SP-20-13 / The Lincoln Case File / Name:

Case File: SP-20-13

SUBJECT: SP-20-13 / The Lincoln

SP-20-13 / The Lincoln – Site Plan

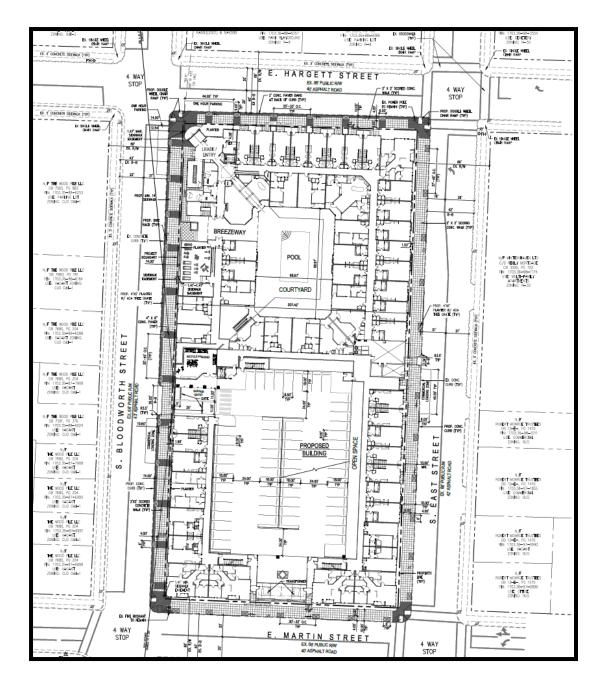
Encourage applicant to provide site furnishings along sidewalks to increase pedestrian interest and comfort.

In areas where foundation planting areas are approximately 2ft in width, the applicant is encouraged to use vines and ground covers in place of shrubs to soften and screen the base of the building.

Introduce more tree variety on Bloodworth and East Street streets capes. Consider using species changes to articulate key entrances to the project.

Increase the level of detail and architectural articulation to all blank brick foundation walls.

Completely screen the parking deck from the right of way.

Use of brick should be increased and if split face block is considered its use should be minimized.

Eliminate the use of cementitious siding where it is close to ground level and replace with durable material like brick

Greater articulation should be brought to all entrances.

The commission supports the 14' sidewalk easement. If a variance is granted to 12' as requested, the resulting streetscape should eliminate tree lawns and install tree grates.

Response: Trash receptacles and bike racks have been added but the developer feels that all seating on should be in secure areas. See sheet LS1.1

We will use appropriate planting materials That will work with the depth of the planting bed.

We have consulted with the Urban Forester and added different species at building entries on all streets. See sheet LS2.1.

We have added additional building entries and windows to the mid block ground level areas of both Bloodworth and East Streets. In addition, contrasting brick banding has been added to those areas. Along Martin Street we have added and an additional pedestrian gate, contrasting brick banding and have added additional brick details to the courtyard wall. The building geometry largely screens the parking garage. It is only exposed behind the landscaped courtyard and is more than 40'-0" back from the sidewalk. We plan on painting the spandrel panels that are behind the landscaped courtyard.

We have added some additional brick and broken up the brick around the building by using a number of different brick colors. Where we plan on using additional masonry will not use a split face block.

We have replaced the cementious siding at the corner of Hargett and East Streets with brick. That was the corner that it was closest to the sidewalk. At the project's two southern corners the cementisious siding is always greater than 6'-0" above sidewalk and is typically between 7'-0" and 8'-0" above the sidewalk.

We have added additional articulation to the building entries

We have talked to Urban Design Center and revised the previously proposed sidewalk sections on Hargett, East and Martin Streets based on comments from the Appearance Commission. The current proposal is to provide a 10' sidewalk from back of curb with a 2'x2' grid pattern, 4'x6' tree grates. There will be no brick pavers on East and Martin Streets

but they will be on Bloodworth and Hargett Streets. This will increase the planting area at the base of the building.
